CUSTOMER TECHNICAL MEMO # 208

Subject: CSD INTERLOCK ANTI-LIFT BLOCK

Date: 25-06-2014

Item Name: CSD INTERLOCK ANTI-LIFT BLOCK

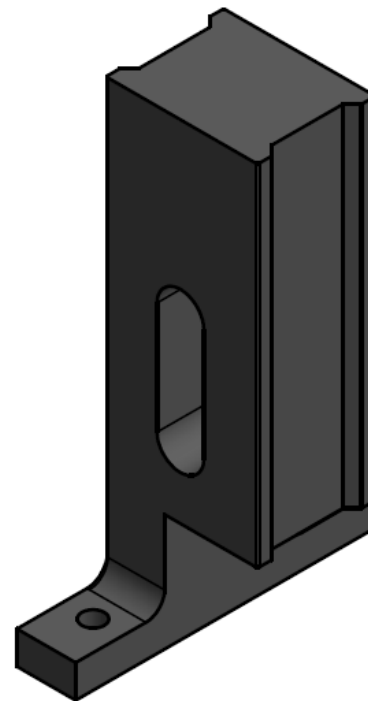
We have received feedback from our customers that the original design of our CSD INTERLOCK ANTI-LIFT BLOCK was prone to damage of the fixing feet during transport to the installation site.

We have improved the design of this product so that it is now installed onsite to avoid the possibility of damaging the fixing feet during transport.
